MEMORANDUM

RE: CURRENT STATUS OF RED HILLS AGI WELL NO. 1 UNDER COMMISSION ORDER NO. R-13507-E

Well Name: Red Hills AGI Well No. 1 (30-025-40448)

Injection Authority: Commission Order Nos. R-13507 through R-13507-E

Red Hills AGI Well No. 1: Unit I, Sec 13, T24S, R33E, NMPM; API 30-025-40448
Commission Order No. R-13507 (as amended): Review of Recent Well Completions in Vicinity of AGI Well (As of 09/28/2017)

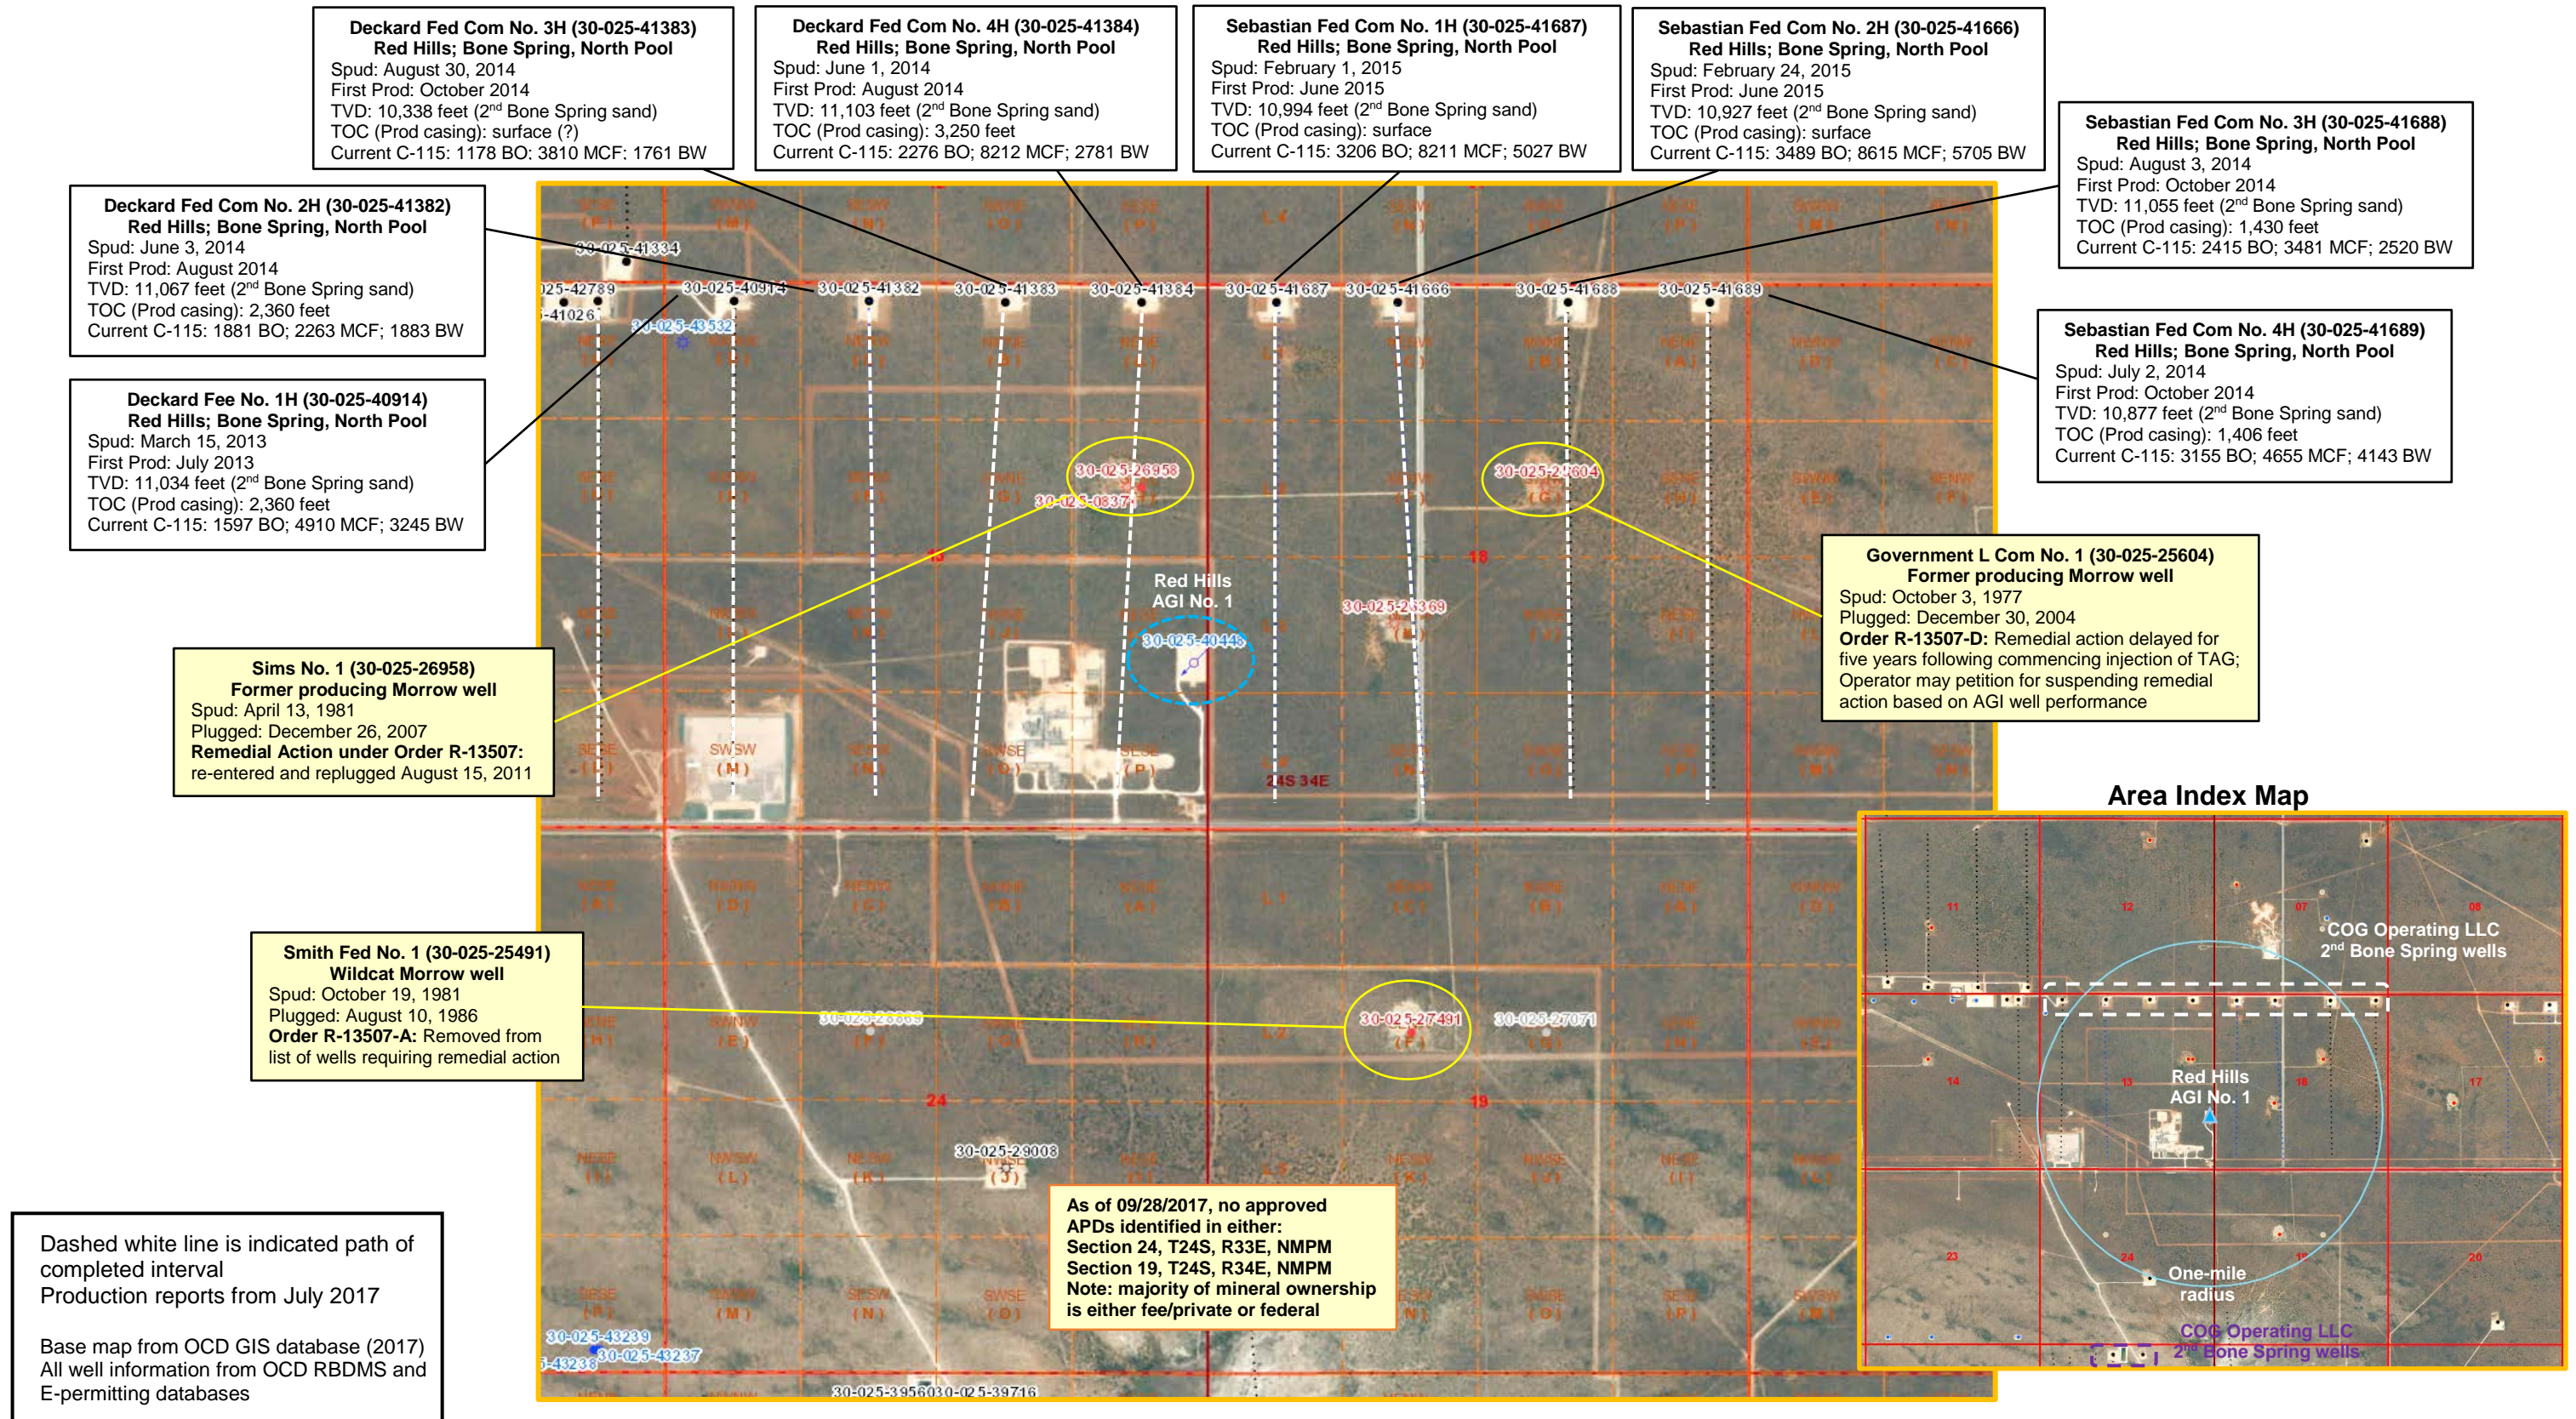
In response to the proposed completion of the AGI well, Division reviewed recent drilling activities in the vicinity of the well and compared this information provided in the original application. This review found expanded production in the Bone Spring Formation, principally the 2nd Bone Spring sand. Since the completion of the AGI well, COG Operating LLC has completed seven, one-mile horizontal wells in Section 13 (T24S, R33E) and adjoining Section 18 (T24S, R34E) (see attached map). True vertical depths (TVD) for these wells range from 10,338 feet to 11,103 feet. There is no record of any horizontal

Development of the Avalon Shale or Upper Bone Spring Shale in this area is found approximately 1.5 miles to the south of the AGI well location. The closest well completions in this shallower unit are found in Section 25, T24S, R33E, NMPM, and are assigned to the Red Hills; Upper Bone Spring Shale Pool (pool code 97900). Current completions show a TVD of approximately 9,400 feet.

Based on the depth of the production for the new Bone Spring wells and the current trend in development in the area, there is no indication that the disposal operations will interfere with the hydrocarbon development in the upper Bones Spring formation.
